Federal Register

40 CFR Part 63

**National Emission Standards for
Hazardous Air Pollutants for Source
Categories: Organic Hazardous Air
Pollutants From the Synthetic Organic
Chemical Manufacturing Industry and
Other Processes Subject to the Negotiated
Regulation for Equipment Leaks; Final
Rule**

ACTION: Final rule; amendments.

Figure 1. ALTERNATIVE EXPERIMENTAL METHODS FOR DETERMINING THE FRACTION OF ORGANIC COMPOUND BIODEGRADED (Fbio) IN A BIOLOGICAL TREATMENT UNIT

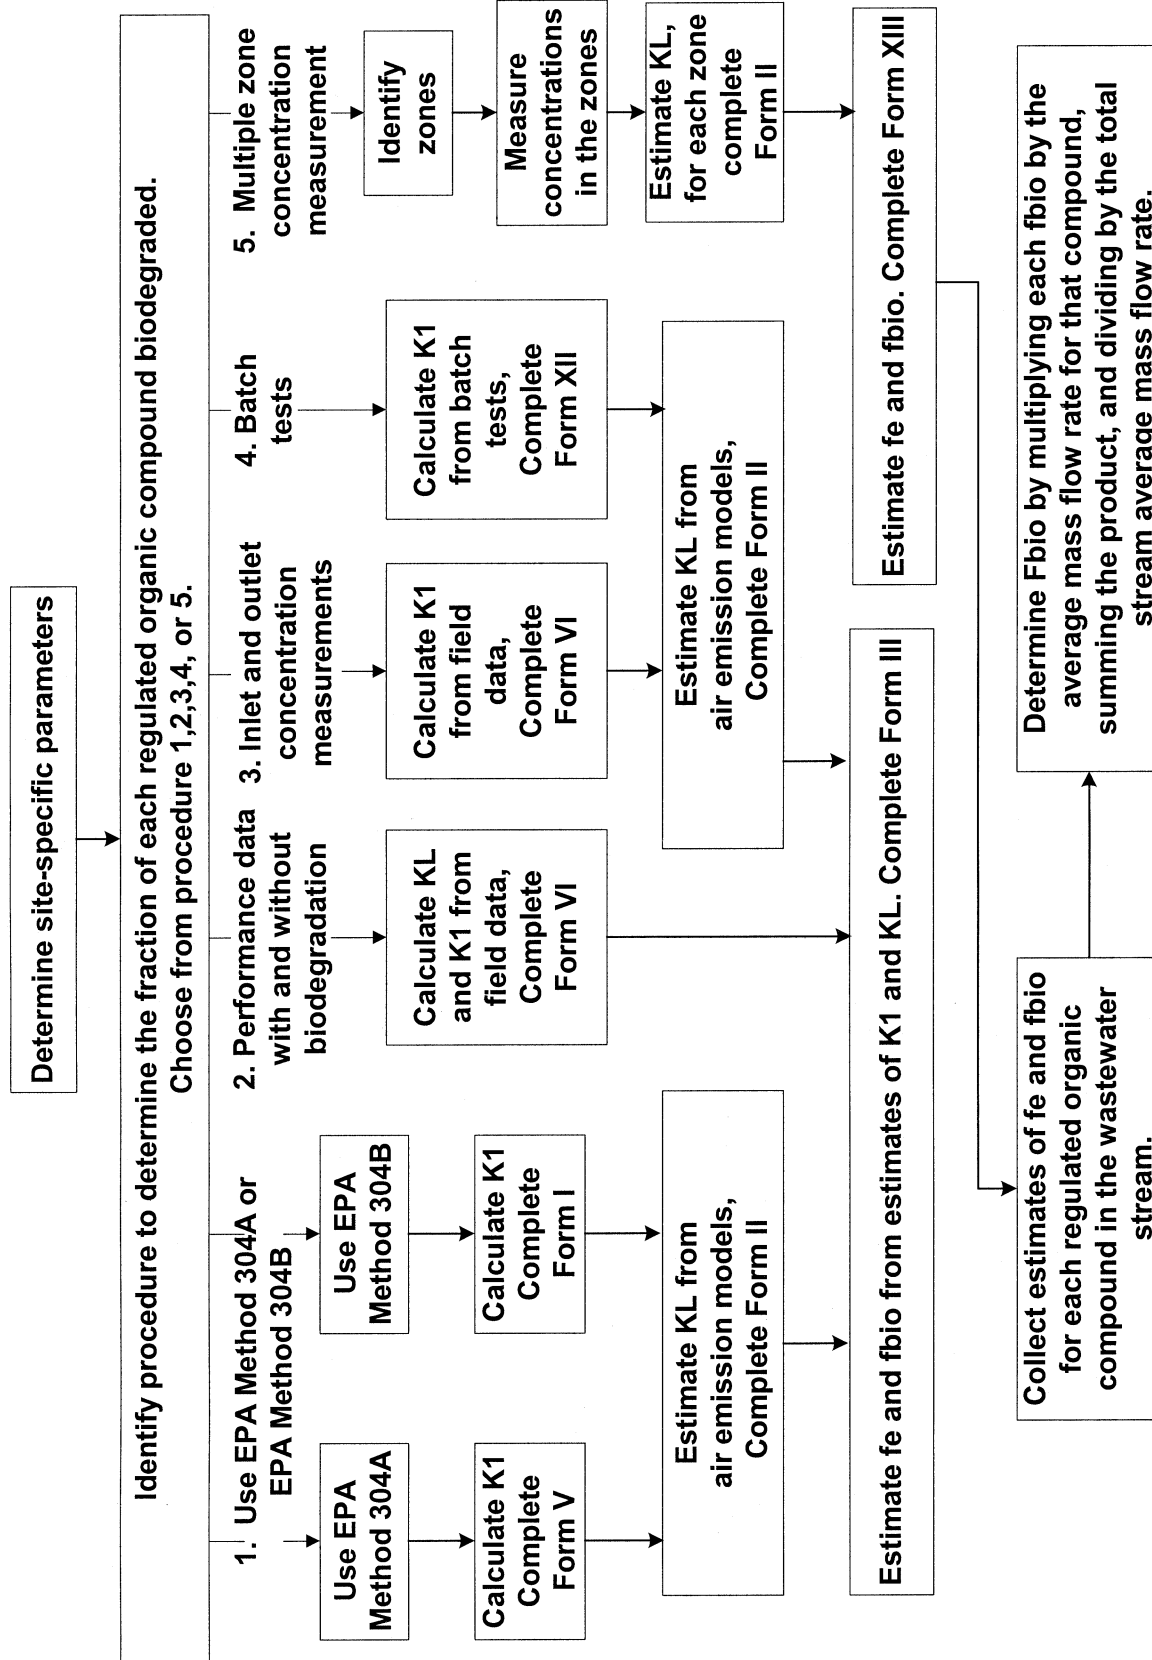
g. Revising Figure 1; and

performance data on a biotreatment unit prior to and after addition of the microbial mass. An example where Procedure 2 could be used is an activated sludge unit where measurements have been taken on inlet and exit concentration of organic compounds in the wastewater prior to seeding with the microbial mass and startup of the unit. The flow chart in figure 1 outlines the steps to use for each of the procedures.
